MEMORANDUM

From: Planning Control Manager **To:** Chief Officer Planning & Regulatory
Our Ref: EP/DC/P/2018/1063 **Your Ref:** MRJ/P/2018/1063
Date: 15th May 2019

Location: O. S Grid Ref: 350 545 Land West of Bryn Isa, Vicarage Lane, Gresford, Wrexham.
Development: Proposed residential development for 44 no. residential dwellings (of which 25% - 11 no. will be affordable), public open space, landscaping, means of highway and pedestrian access, local highway and pedestrian infrastructure improvements along Vicarage Lane, foul sewerage pumping station and new off-street parking provision for existing residents.

I refer to your consultation / email dated 03/05/2019, letter from Axis dated 25/04/2019 and revised layout plan (Drg. No. PL-002 Rev D) in respect of the above.

Turning Areas

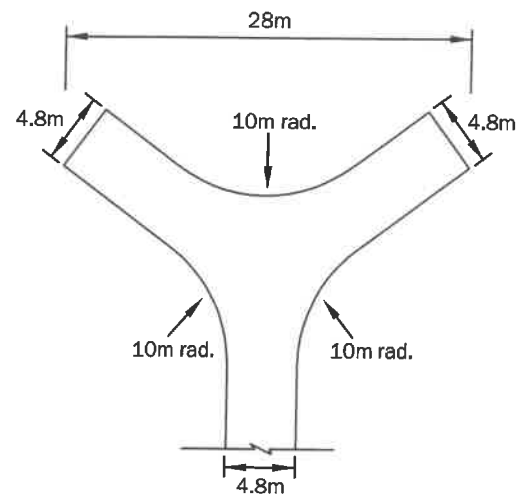
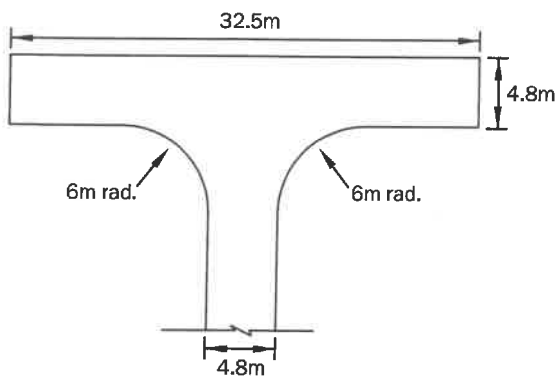
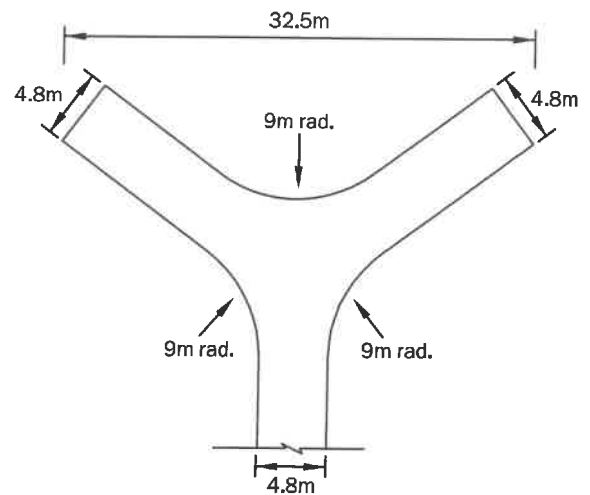
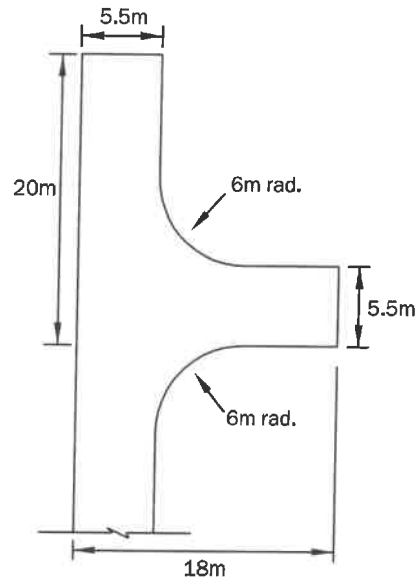
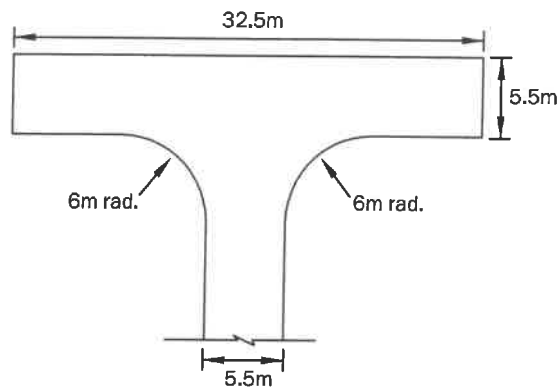
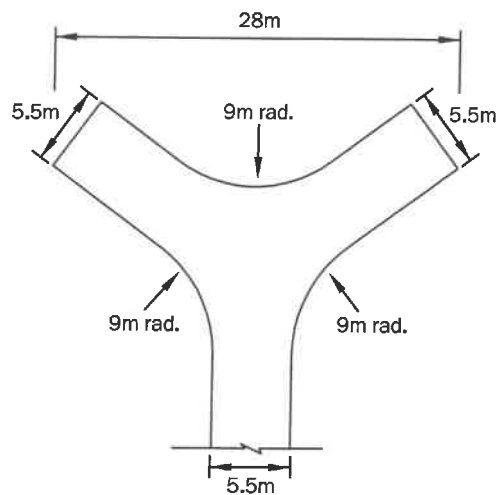
Indicates a 3.5T Panel Van turning within the access road serving plots 1 – 8. I would recommend that a suitable turning head is provided to accommodate the turning movements of a medium sized delivery vehicle (see attached detail). Please ask the applicant to provide an amended layout plan indicating this detail.

Indicates a 7.5T Box Van turning within the access road. I would recommend that a suitable turning head is provided to accommodate the turning movements of an 11.2m long refuse vehicle (see attached detail). Please ask the applicant to provide an amended layout plan indicating this detail.
